In the Matter of)	
)	Docket 50-344
PORTLAND GENERAL ELECTRIC COMPANY,)	
et al)	(Control Building Proceeding)
)	
(Trojan Nuclear Plant))

I hereby certify that on July 10, 1979, Licensee's letter to the Director of Nuclear Reactor Regulation dated July 10, 1979 and an attachment entitled "Request for Additional Information, Trojan Nuclear Plant, Proposed Control Building Design", have been served upon the persons listed below by depositing copies thereof in the United States mail with proper postage affixed for first class mail.

Trojan Nuclear Plant
Docket 50-344
License NPF-1

Enclosed are the answers prepared by Bechtel Power Corporation to the remaining five questions from your letter of May 18, 1979. This submittal answers the last of the formal questions posed by your staff. A revision to PGE-1020 covering updated information will be issued shortly.

Figure 46-16 Secant Modulus, Specimen H-1

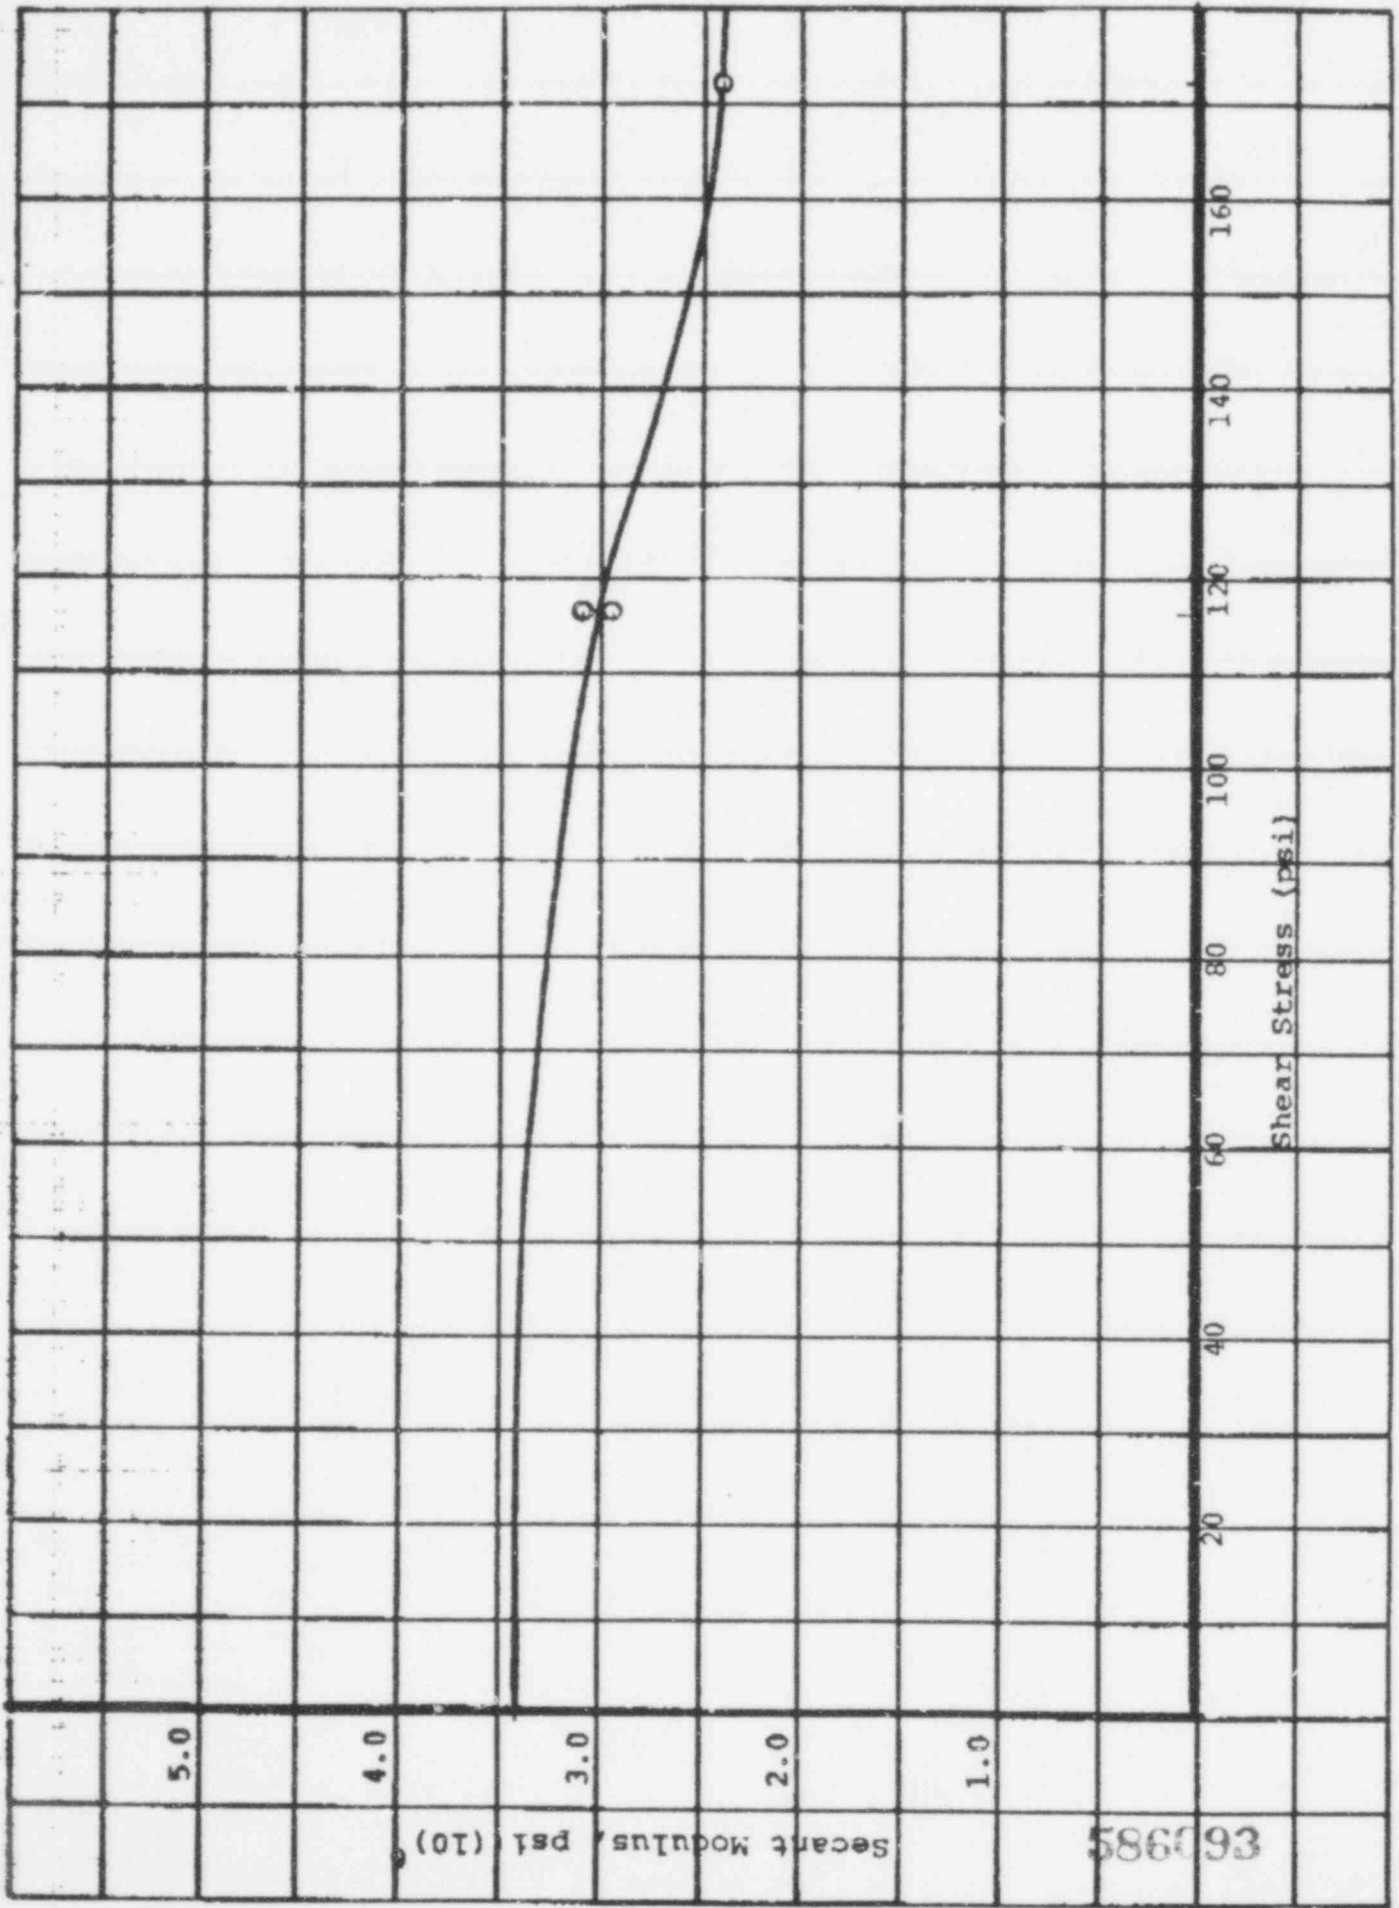
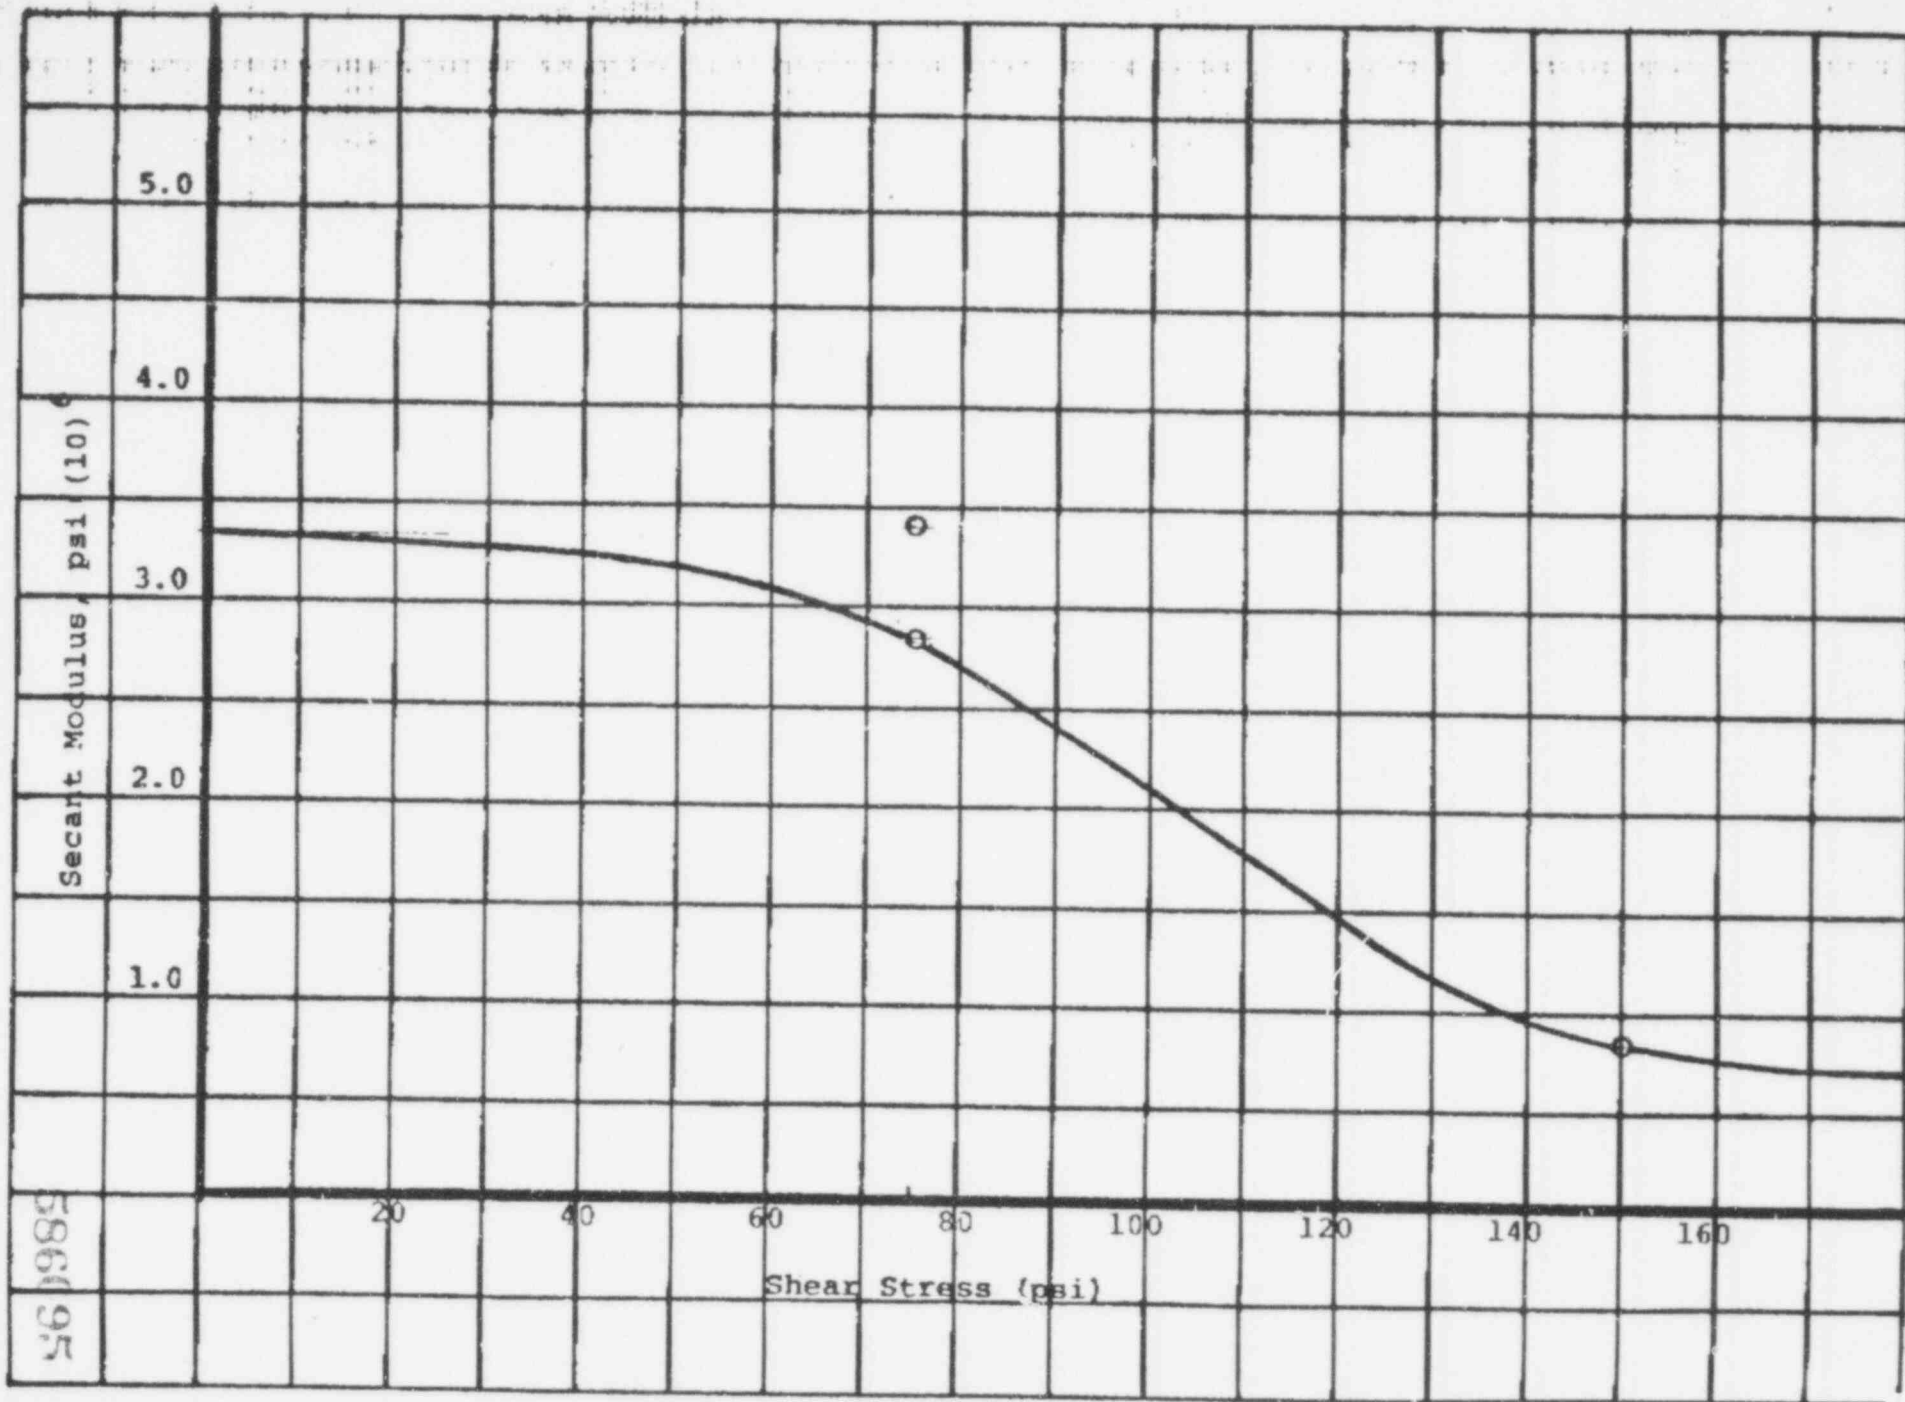
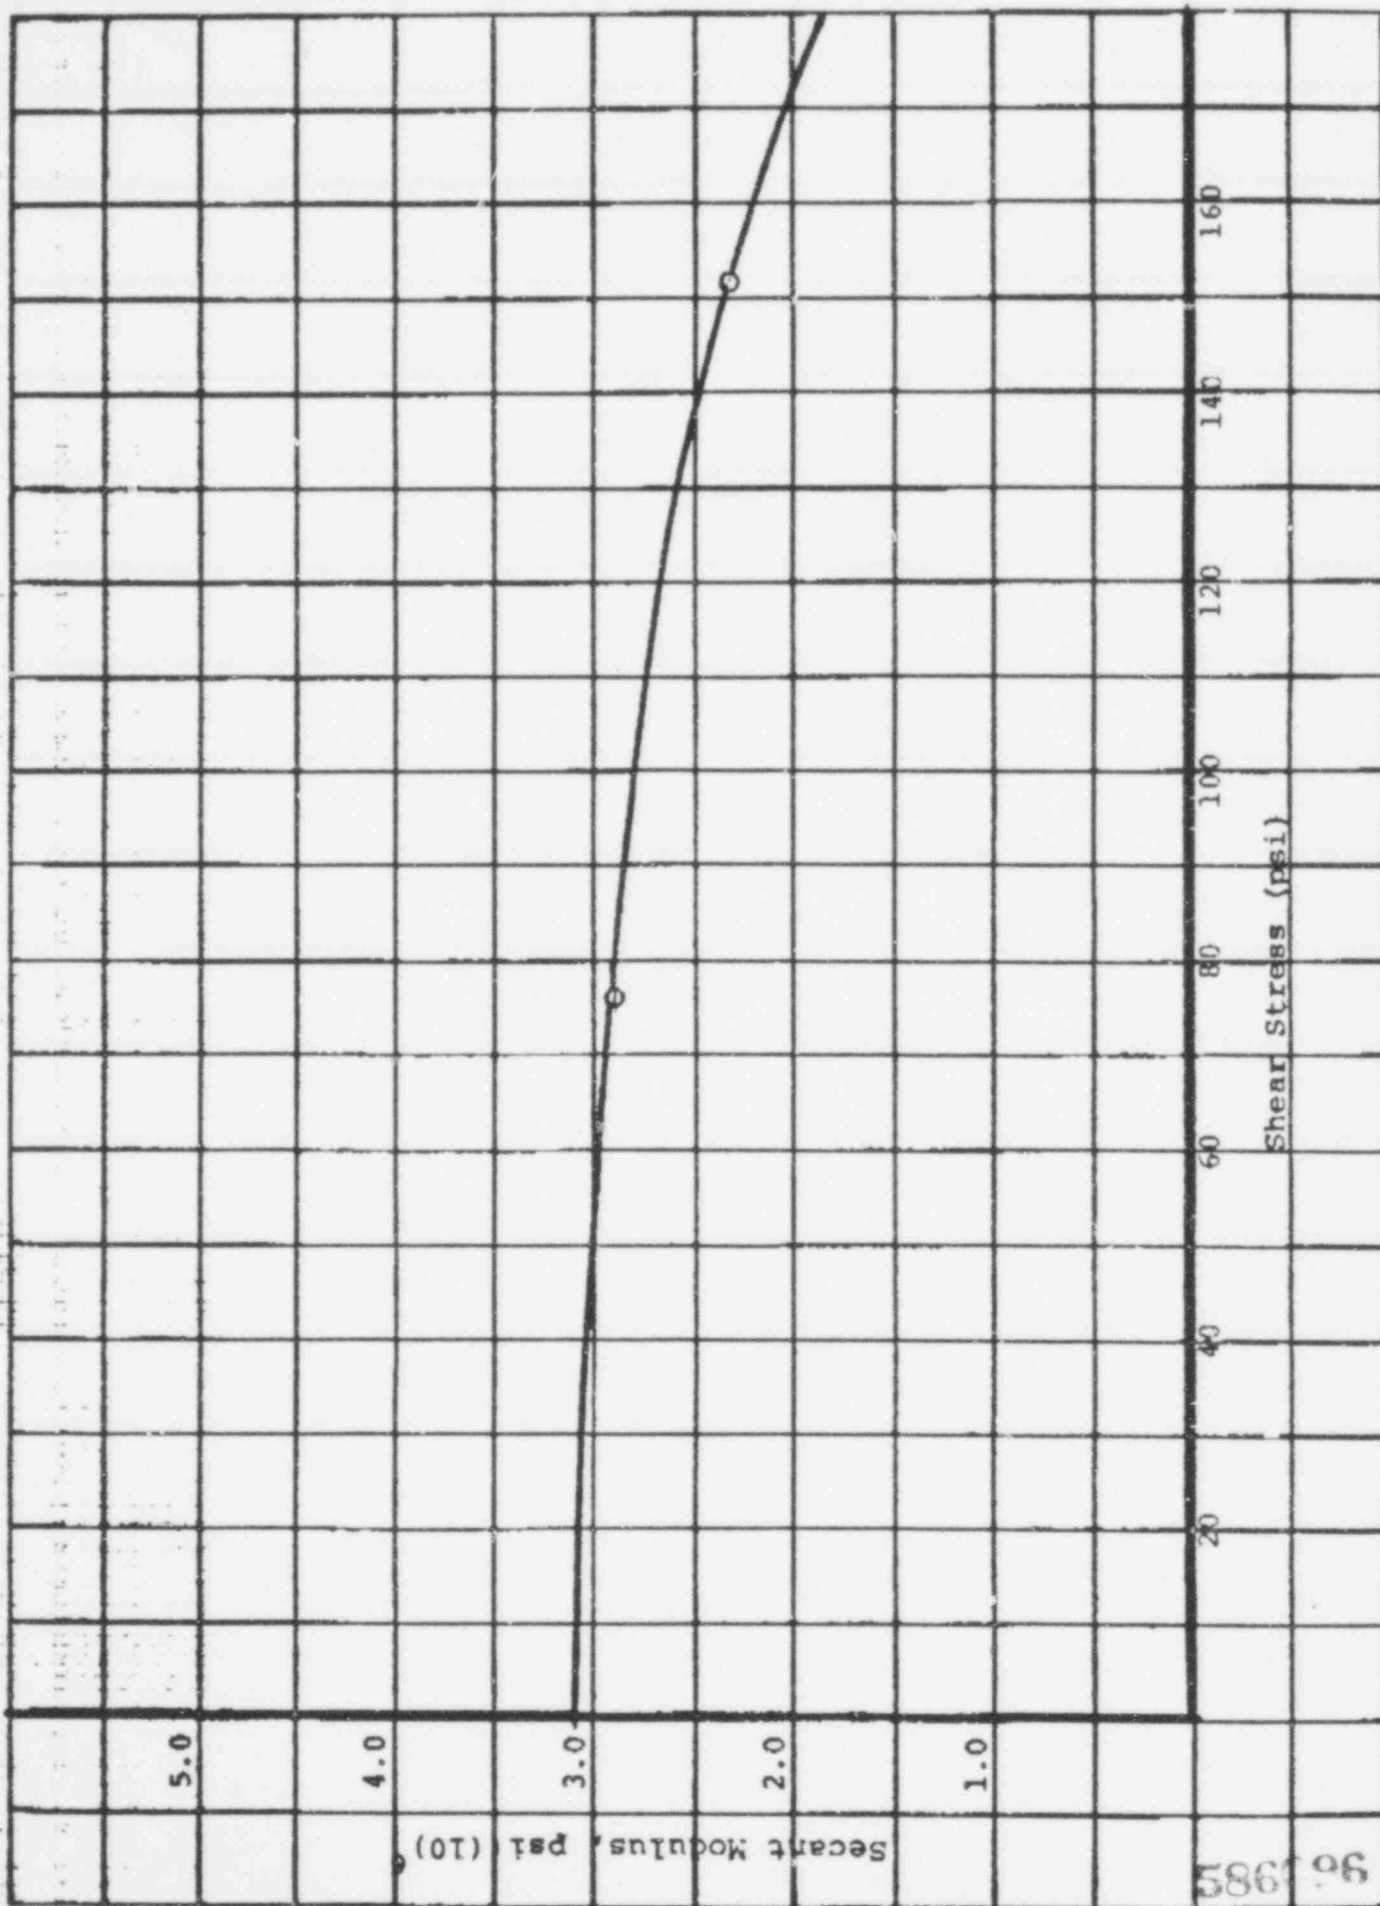
Provide the secant modulus derived for each of the test specimens vs. stress level; a comparison of the experimental initial elastic modulus for the test specimens vs. that calculated using the formula in Section 2.2.1.3.2 of Appendix B; the error bands, and their deviation, for the curves representing stiffness reduction as a function of stress level; and the stresses in each of the walls resulting from incorporation of the stiffness reduction factors in the STARDYNE model along with the associated stiffness reduction factors assumed in the analysis.

The secant modulus vs. shear stress for the test specimens is shown in Figures 46-1 through 46-20. A comparison between the experimental initial elastic modulus and that calculated using the formula in Section 2.2.1.3.2 of PGE-1020, Appendix B cannot be made since the initial modulus cannot be determined experimentally. The instrumentation was not sufficiently sensitive to measure the small deflections required for the calculation. Deflections need to be measured reliably to the nearest .0002 inch at the early stages of deformation. During this stage, the test specimen and load frame is settling in, play in instrumentation is being taken up, etc. Care was taken to minimize these effects but all could not be completely eliminated since the movements being considered are between 1 and 10 times smaller than the thickness of this paper. Some difficulty was even encountered at the first load step but for the other load steps the deflections were

large enough so that effects were not important. As shown in Figures 46-1 to 46-20, there are in general two data points at the first load step. The top part is obtained from the average deflections recorded on each side of the specimen and the other is obtained from the most active dial gauge. The initial modulus used in the plot was calculated using the equation in PGE-1020, Appendix B. An error analysis of the data could not be made since there are not enough specimens with duplicate conditions to provide sufficient data base. The effect of variation is considered in the broadening of the response spectra.
